Program Bulletin

CUSTOMER SATISFACTION PROGRAM

SUBJECT: Tail Lamp Gasket Seal

MODELS: 2014 Chevrolet Impala

3649621

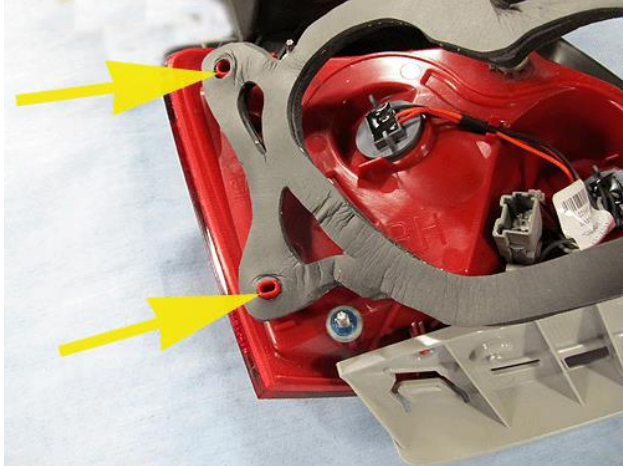
- 4. Slowly peel the seal away from the housing, using care to remove the adhesive from the housing. **Tip:** Removing the seal at a 45 degree angle while slightly stretching the rubber will remove most of the adhesive with the seal.

3649624

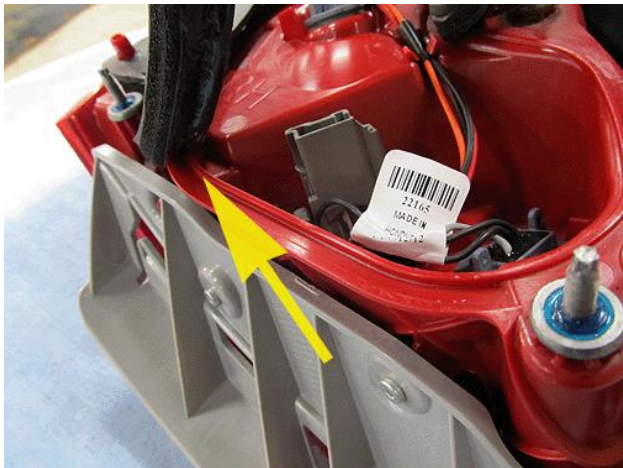
- 5. Clean any old adhesive from the tail lamp housing using a general purpose adhesive remover.
- 6. Start the new seal application by placing the two outer alignment pins through the holes on the seal. Ensure that the adhesive side of the seal is facing the tail lamp.

3649627

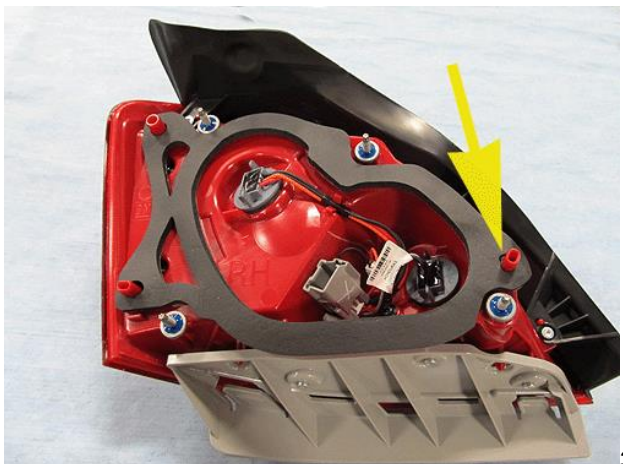
- 6.1 Install the seal, ensuring that it is centered on the compression ribs on the tail lamp housing as shown.
